**Property:** 27-31 Belmore Street, Burwood

**DA No:** 89/2012

<b>PROPOSAL</b>	Mixed Use Development: 3 storey podium and 3 residential towers (of 12, 13 and 14 storeys above) containing 222 residential units, 8,718m <sup>2</sup> of commercial/retail space, with 6 basement parking levels
<b>ZONE</b>	Mixed Use – B4
<b>IS THE PROPOSAL PERMISSIBLE WITHIN THE ZONE</b>	Yes
<b>IS THE PROPERTY A HERITAGE ITEM</b>	No
<b>BCA CLASSIFICATION</b>	2, 6 and 7a
<b>NOTIFICATION</b>	Neighbours: 16 August 2012 to 17 September 2012

Planning Ingenuity Pty Ltd has been engaged by Burwood Council to provide the Joint Regional Planning Panel (JRPP) with an independent town planning assessment of this application, including the preparation of this report. Planning Ingenuity Pty Ltd has been assisted in this process by GM Architects and Urban Designers (GMU) and McLaren Traffic Engineering to provide an independent assessment of the proposal in relation to urban design and traffic related matters.

Figure 3: Separation model (page 45 – Project Design Report prepared by AJC)

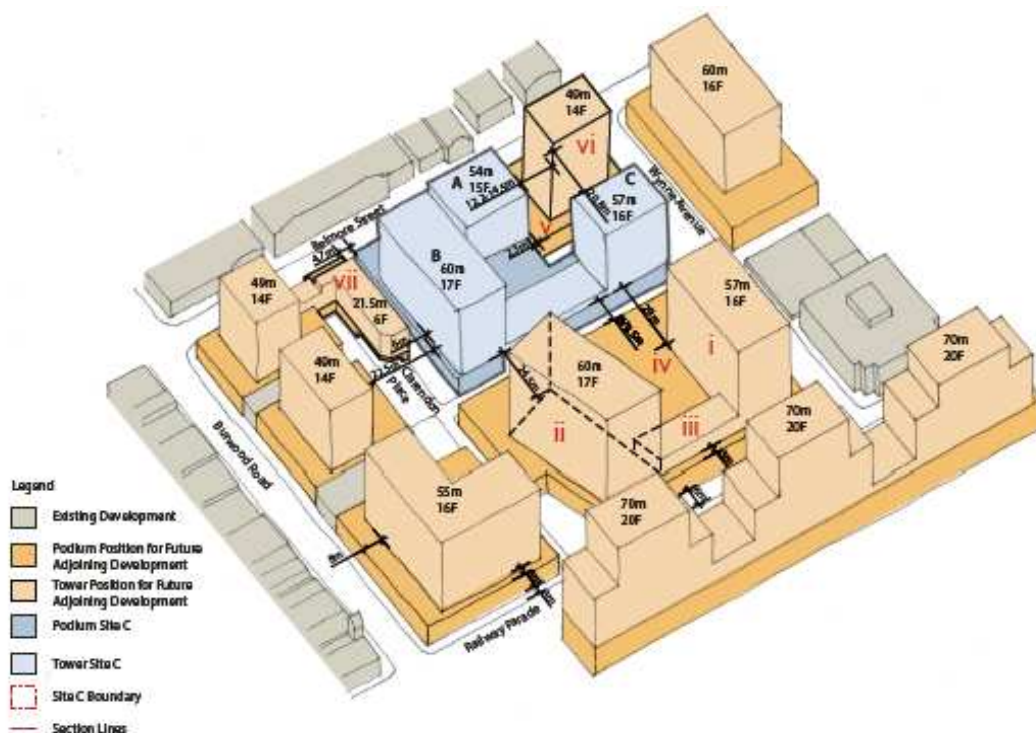
Of assistance to this assessment, the applicant has provided indicative future development options for adjoining development to illustrate potential sharing of separation requirements and submits that suitable building separation could occur in the event that surrounding sites were redeveloped (see figure 3).

**Figure 5: Suggested design modification (page 8 GMU Urban Design Assessment)**

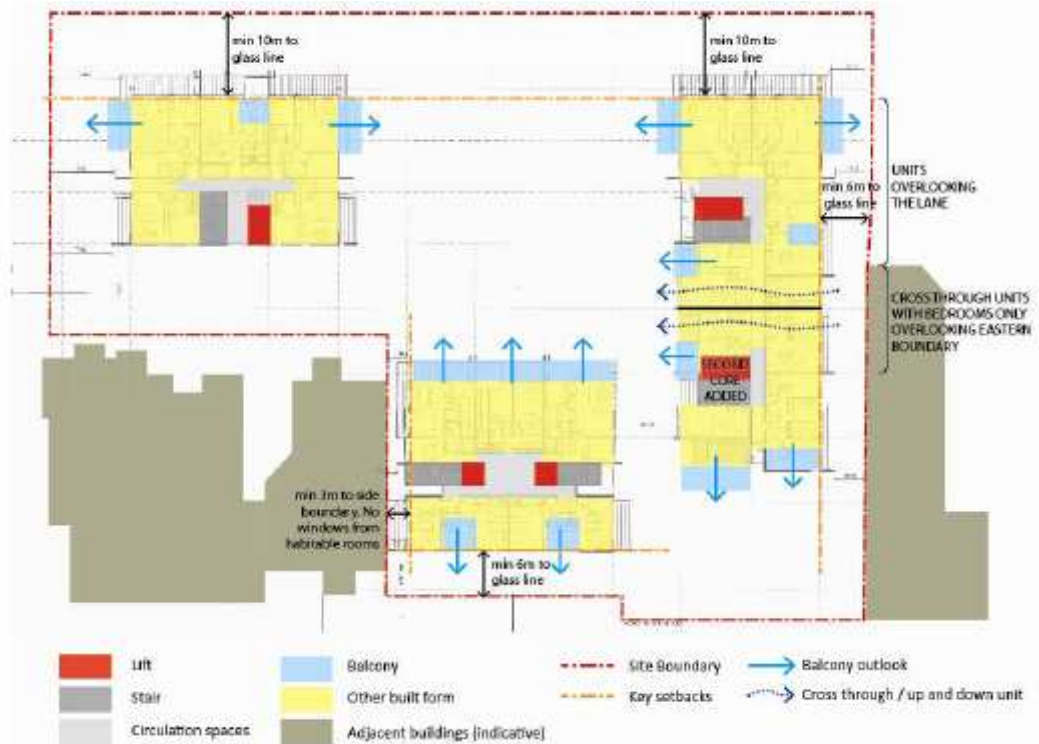
Whilst the proposal provides in excess of 50% of the total separation distance up to 4 storeys, it does not provide its 50% share of the 18m separation required between 5 and 8 storeys or 12m required over 9 storeys. Rather the proposal provides a 7.9m setback from the northern boundary which is up to 4.1m deficient of providing half of the separation. Note, given the requirements for residential/commercial split of uses on the Burwood Plaza site, only 18m may be required for separation to parts of future towers.

Whilst these constraints to achieving compliant building separation are noted, GMU has developed a potential alternative solution that is considered to result in a superior relationship between the subject site and No. 25 Belmore Street. This is identified in Figure 5 above and is summarised as follows:

Accordingly, it is considered that design changes are required to the western elevation of proposed Tower A. GMU has considered this issue in their report and has tested potential solutions (refer to Figure 5). The solution would include removing balconies and habitable windows facing west, maintaining at least a 3m setback to the western boundary and orienting any private open space to the north and south. These changes would require internal reconfiguration of this building and therefore could only be undertaken through further design work in consultation with Council as opposed to being addressed by conditions of consent.

- Southern units to look to Belmore Street.
- Addition of a second core to allow for cross through units or up and over units that have main living areas oriented to the landscaped courtyard and only bedrooms looking at the side boundary. The building envelop is to provide a 6m setback to the eastern boundary to the glass line with no balconies encroaching on the 6 metres, unless directly overlooking the lane. For the northern units of this tower, an east-west outlook for the private open space is preferred in order to avoid privacy issues with potential development to the north.
- Northern boundary to achieve at least 10m separation to the glass line by redirecting the balconies to the east and west with no private open space projecting into the setback. Living areas can maintain a northerly outlook behind the 10m line.
- North-facing façade to be well articulated.

Figure 6: Separation diagram to the west (page 42 – Project Design Report prepared by AJC)

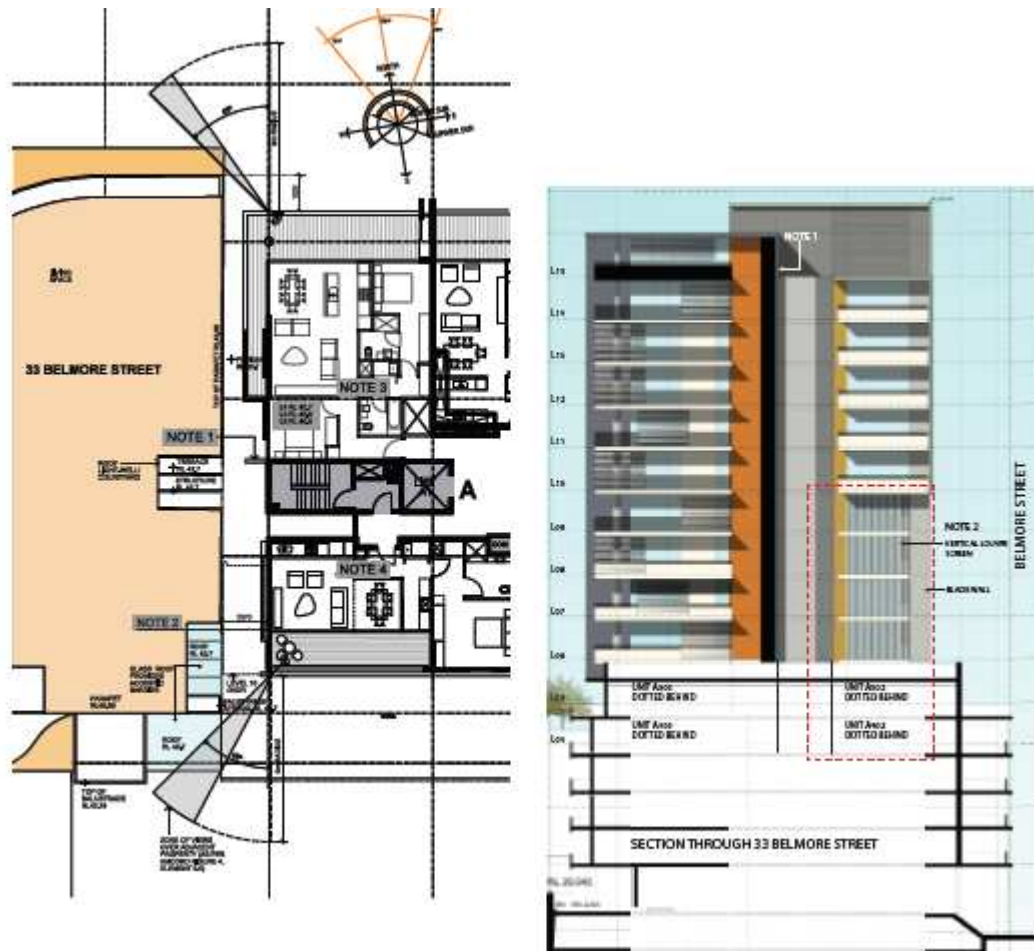
Therefore, the proposal results in non-compliance with building separation requirements both in terms of existing development and potential future development on No. 33-35. In terms of the proposal's relationship with the existing building at No. 33-35, the proposal introduces privacy measures such as blade walls and privacy screens to address potential conflicts with a Level 6 roof light well/courtyard and south facing balconies on Levels 5 and 6 (refer to Figure 6).

**Figure 7: Separation diagram to the east (page 44 – Project Design Report prepared by AJC)**

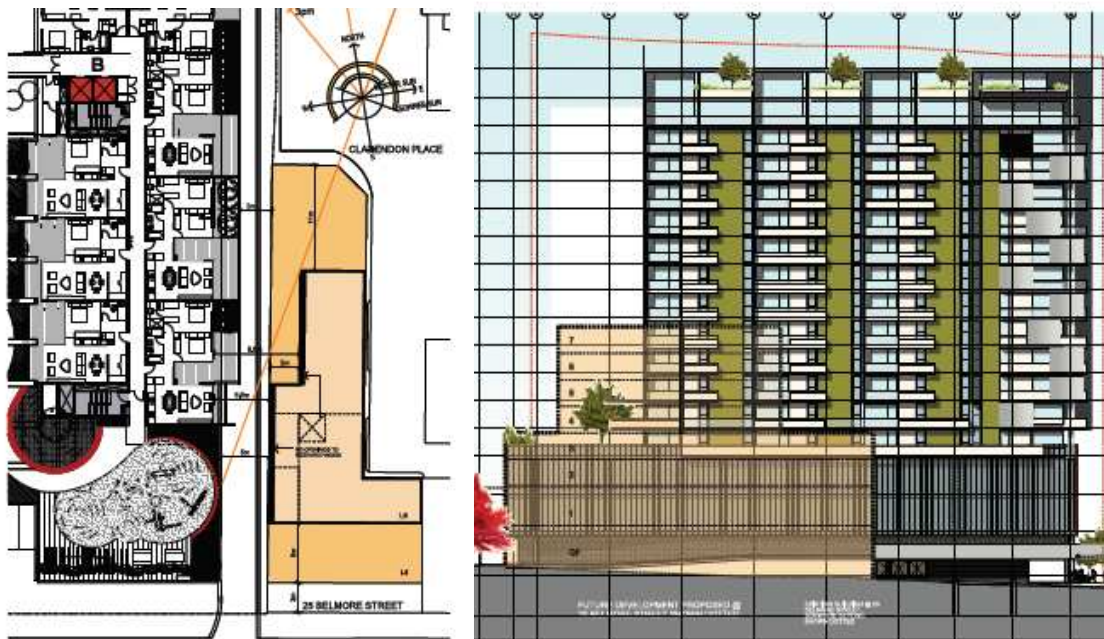
Proposed Tower B is setback from the common eastern boundary with No. 25 Belmore Road by 5m (Level 3) and 4.4m (Level 5-17) The proposed building is however only partly adjacent to the building on No. 25. The southern 42m of the building is adjacent to the adjoining site and north of that, Clarendon Place provides separation to the rear of properties fronting Burwood Road (refer to Figure 7).

The applicant is therefore presented with a scenario that even if they were to provide building separation on the subject site to compliant levels, the property to the east would not be capable of doing the same upon redevelopment. The applicant has provided a conceptual development plan for No. 25 that rather than relying on building separation to provide an appropriate interface between sites, considers a "blank wall" to the west facing the site and orienting units to the north and north-east. Separations of between 5.6m and 8.6m are provided glass line to blank wall (refer to Figure 7).

Figure 8: Internal separation diagram - Towers A & B (page 47 – Project Design Report prepared by AJC)

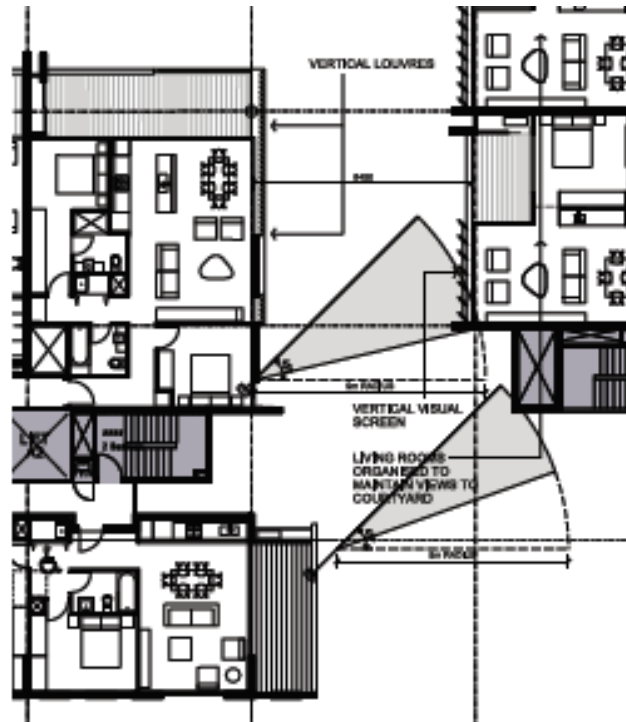
The setback between Tower A and B is 8.45m from Levels 4 to 15. Vertical louvres have been provided to living area glazing of Tower A where it faces Tower B and living areas to Tower B are provided with operable louvres to enable management of privacy from bedroom and balconies of Tower A and still maximise solar access (refer to Figure 8). Generally it is considered that these treatments will adequately alleviate privacy impacts despite the shortfall in internal building separation.
